ADDENDUM NO. 1

October 3, 2024

Whiteland High School Ph 2: Café Kitchen Band Choir Auditorium
300 E. Main Street
Whiteland, IN 46184

1 AUDITORIUM AV SYSTEM DIAGRAM
N.T.S.

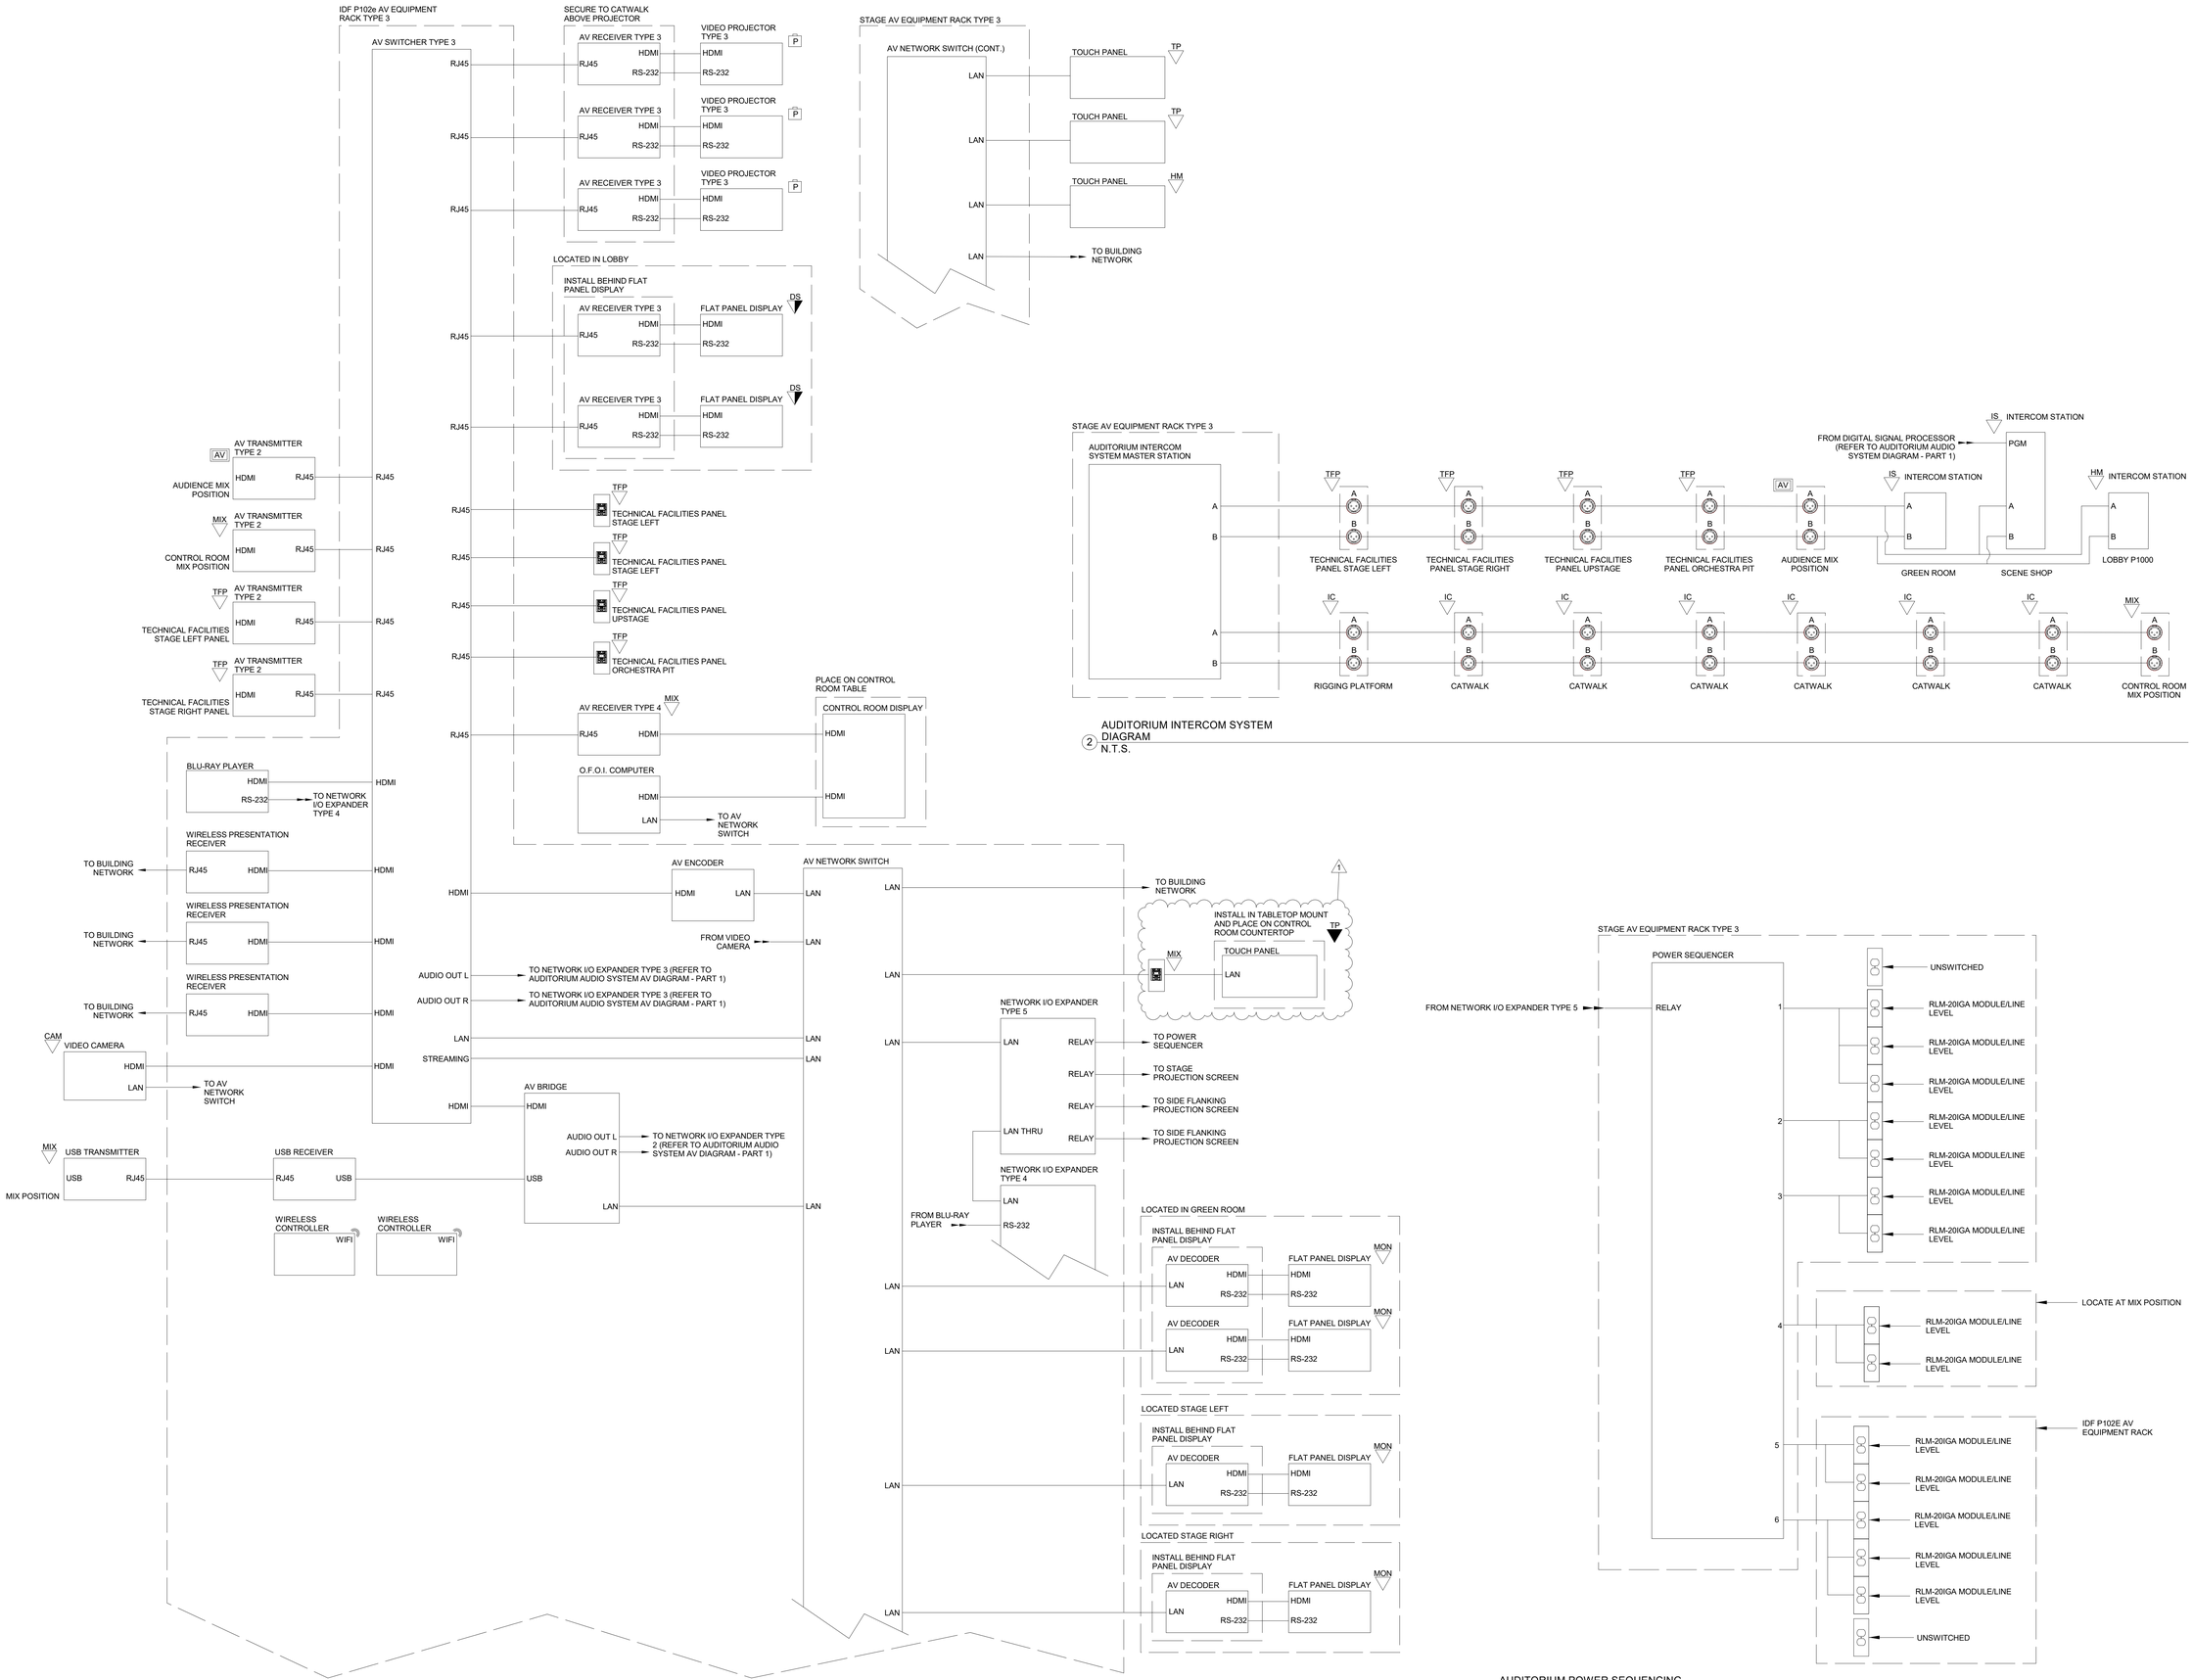
25. Sheet T310 – AUDIO VISUAL DIAGRAMS
- Updated the connection to the tabletop touch panel in the "Auditorium AV System Diagram" to one RJ45 connector terminated in the audio mixing location from the AV network.

1 AUDIO MIXING LOCATION
N.T.S.

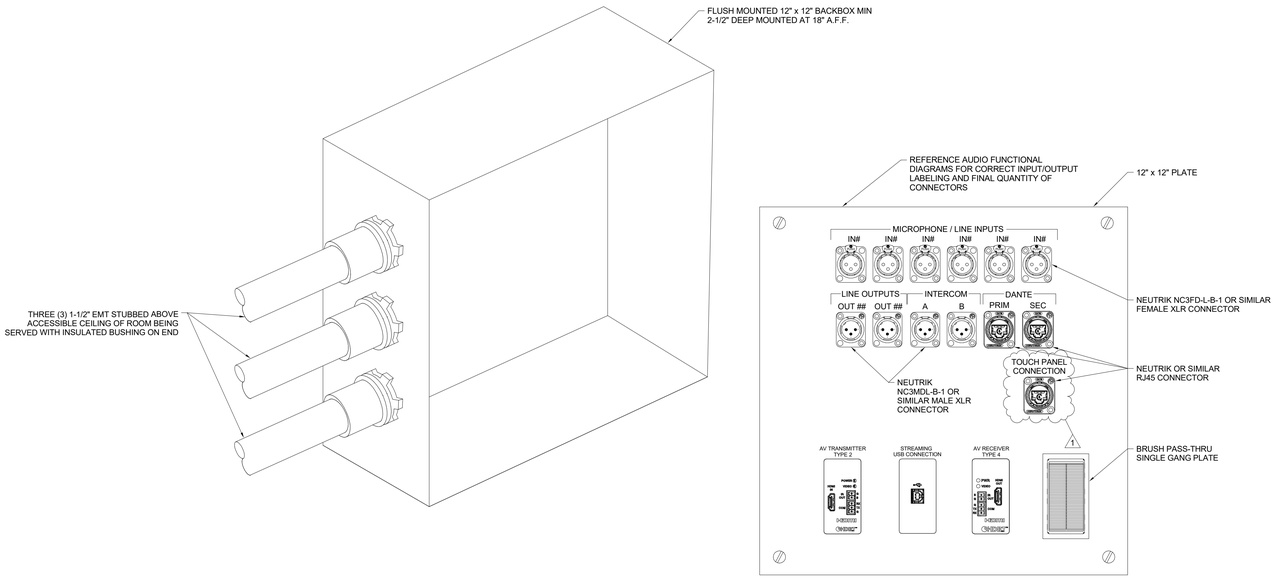
26. Sheet T401 – TECHNOLOGY DETAILS
- Added one tabletop touch panel RJ45 connector to the audio mixing location detail.

8 PROJECTOR LOCATION - CEILING MOUNTED
N.T.S.

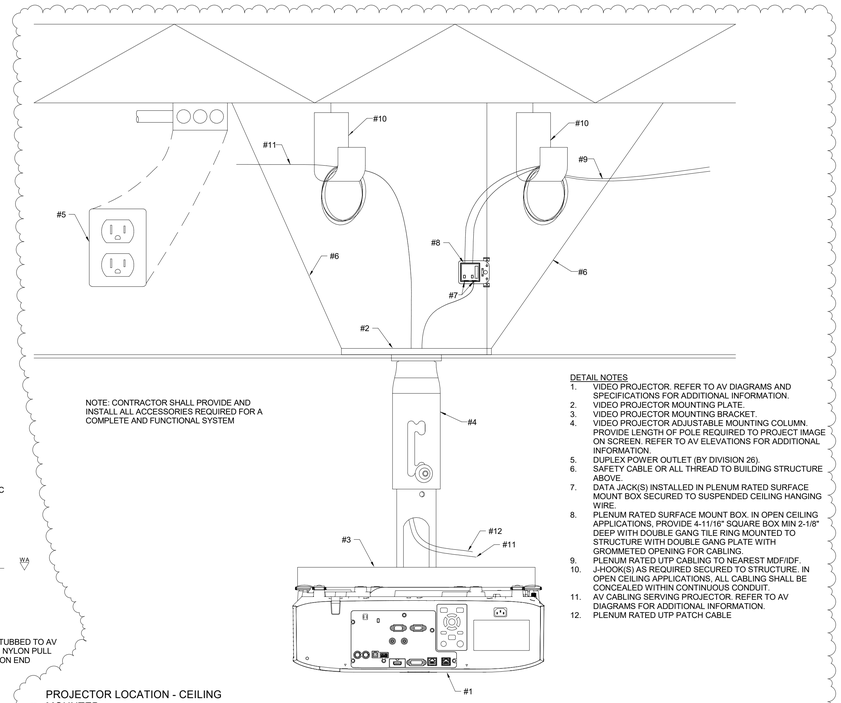
27. Sheet T402 – TECHNOLOGY DETAILS
- Updated the mounting configuration in the ceiling mounted projector location detail. Removed the lay-in ceiling plate configuration.

7 PROJECTOR LOCATION - CATWALK MOUNTING DETAIL
N.T.S.

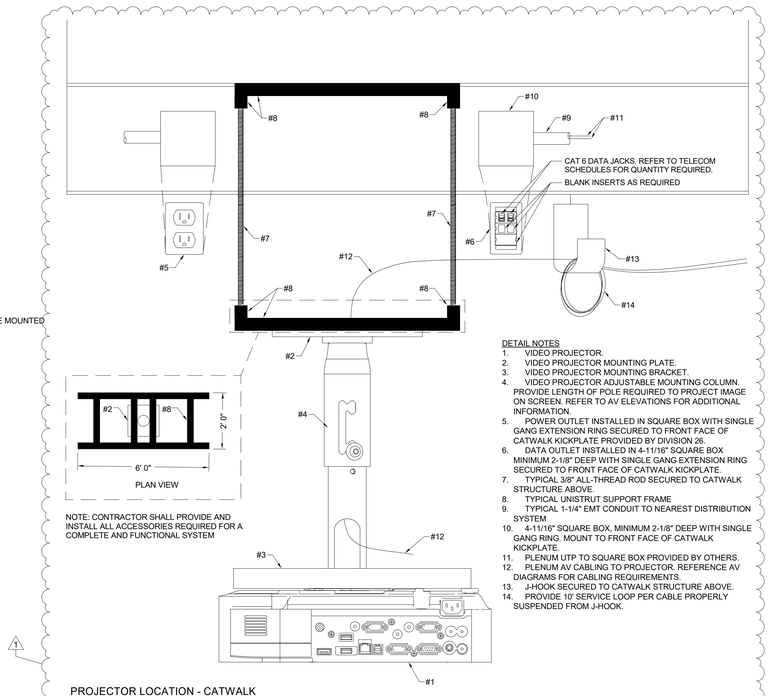
28. Sheet T403 – TECHNOLOGY DETAILS
- Added new catwalk mounting detail for projectors detailing the mounting configuration and infrastructure requirements.

SHEET 300

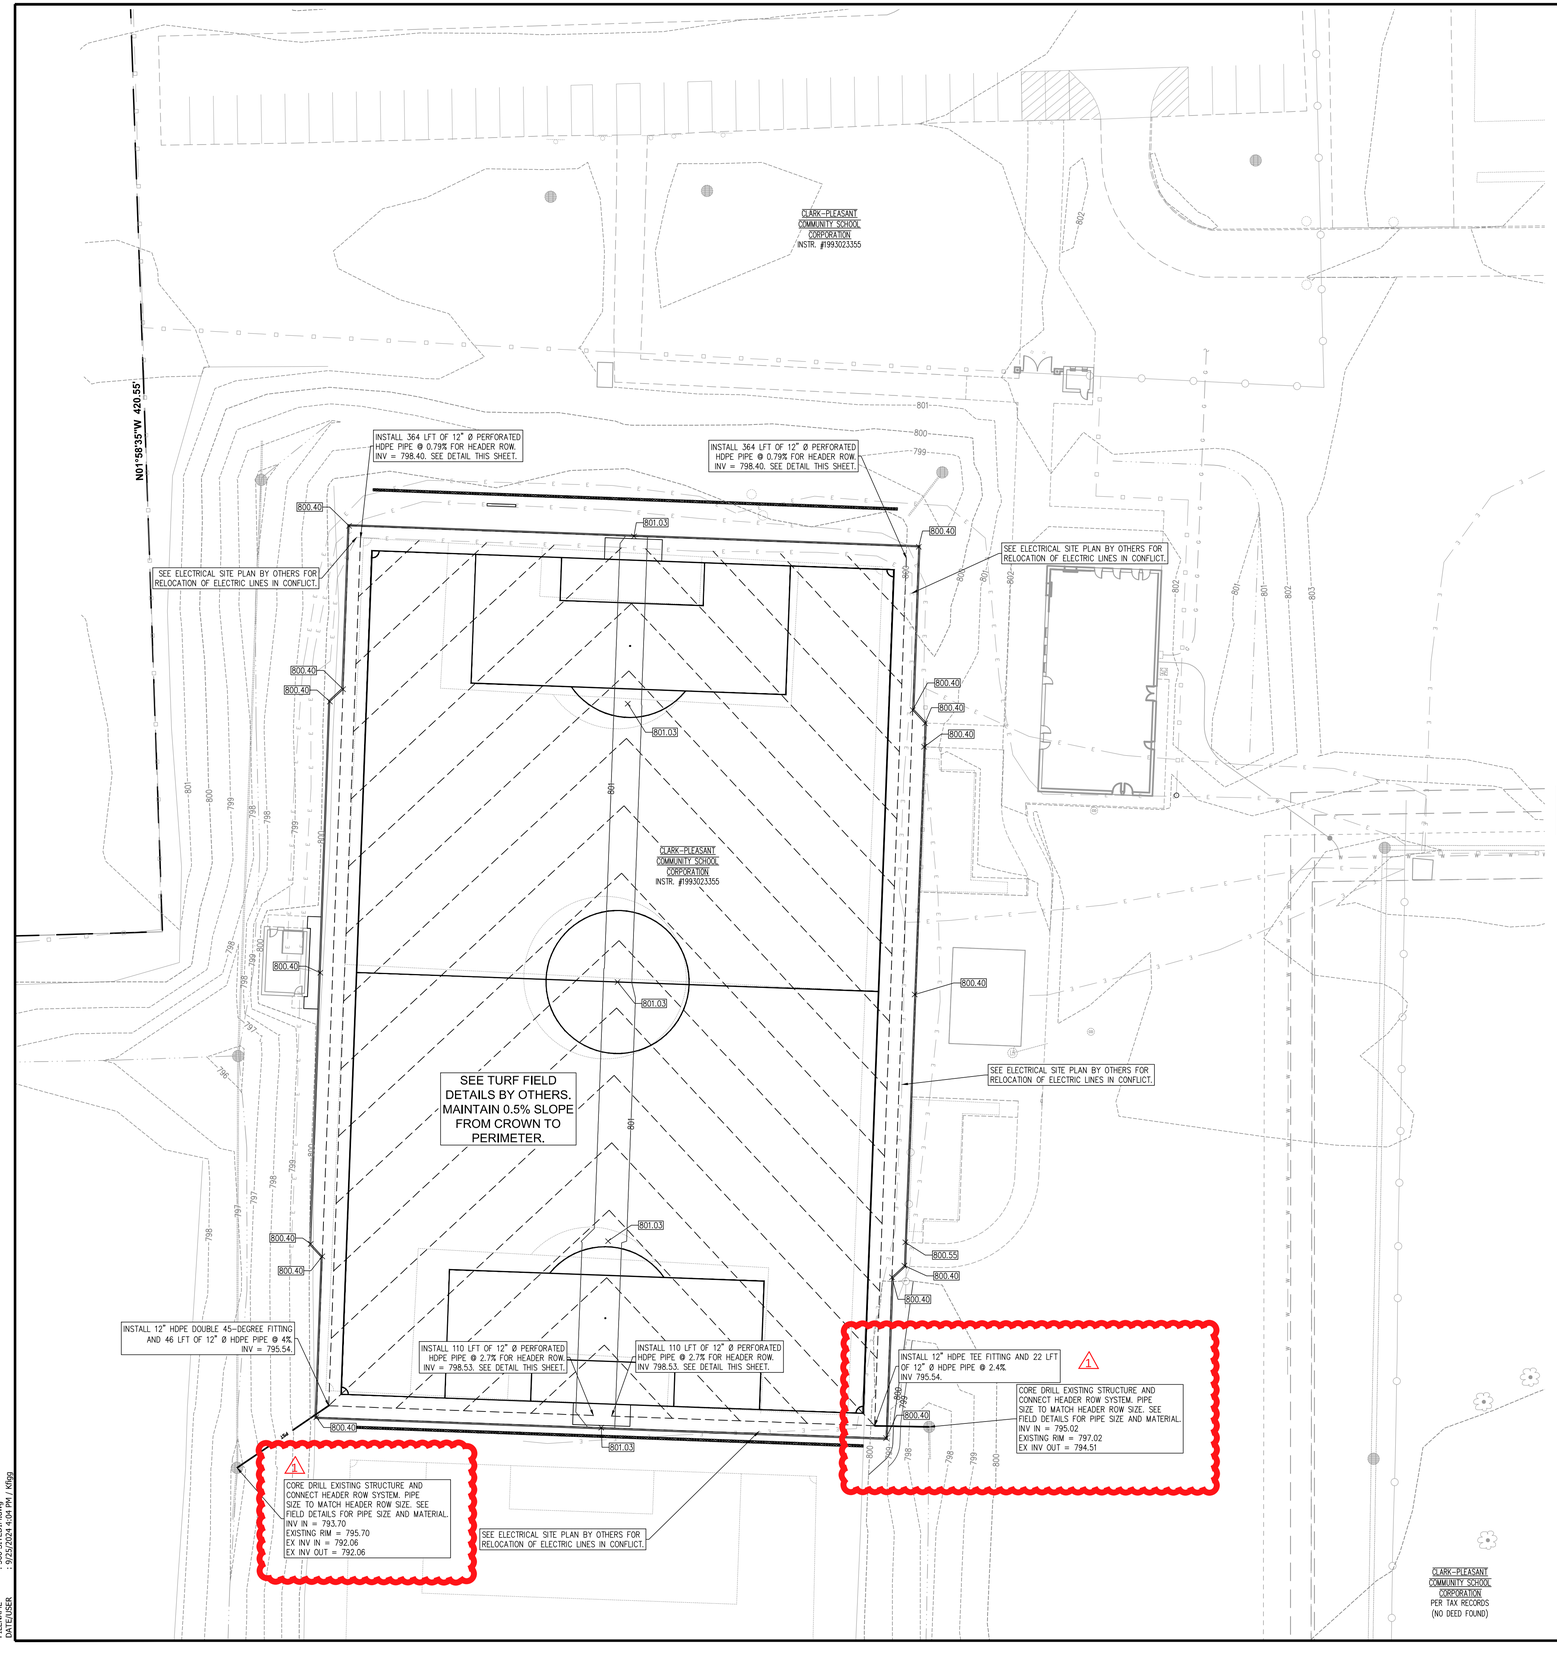
1. Utility and Grading Plan (sheet 300):
- Added proposed contours at SE corner of turf field for 3:1 tie-in to existing grade.
- Added existing rim and invert information to the existing structures that the header rows will connect to.
- Removed unused items from proposed legend and added field underdrains to legend.
